# Access Compliance Report Public Rights-of-Way (Curb Ramps)

Main Street: HEWES\_ST Cross Street: VINE\_ST Location: NE

ADA ID: RPAT210928125135 Ramp Type: Type 4 - Parallel Initial Pass/Fail: Fail Overall Compliance: No Severity Score: 2

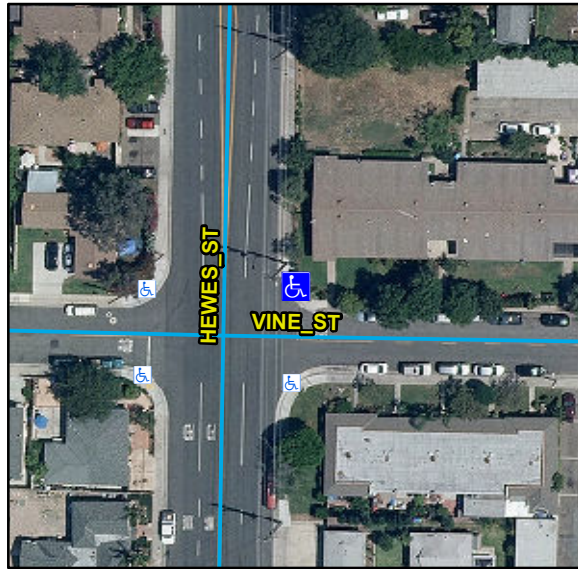
| Compliance | Description                   | Data       | Compliance | Description                   | Data |
|------------|-------------------------------|------------|------------|-------------------------------|------|
| Yes        | Ramp Cross Slope LT (%)       | 0.3        | No         | Ramp Cross Slope RT (%)       | 2.1  |

**Remove & Replace Curb Ramp With Two New Directional Ramps or Equivalent.**

**R304.5.3, STD 1115**
